## NO. SI 40NG-062

Austro Engine Mandatory Service Bulletin No. MSB-E4-024/1  
ATA-Code: 71-00

# MANDATORY SERVICE BULLETIN

## No. MSB-E4-024/1

Example: Turbo charger for engine configuration "-A" with new spring loaded circlip

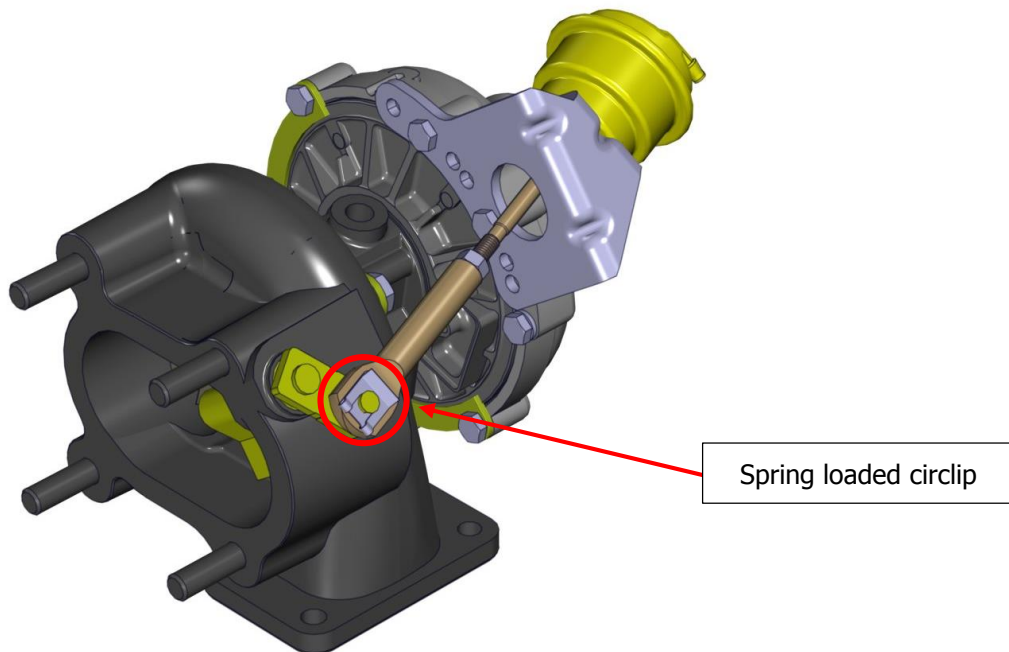
This Service Bulletin describes the replacement of the waste gate circlip, which prevents the waste gate actuator connection rod from disconnecting from the waste gate bolt of the turbo charger. An improved circlip design prevents the incorrect installation of the circlip.

Replace the circlip DIN6799-5 with the spring loaded circlip E4A-41-100-801.
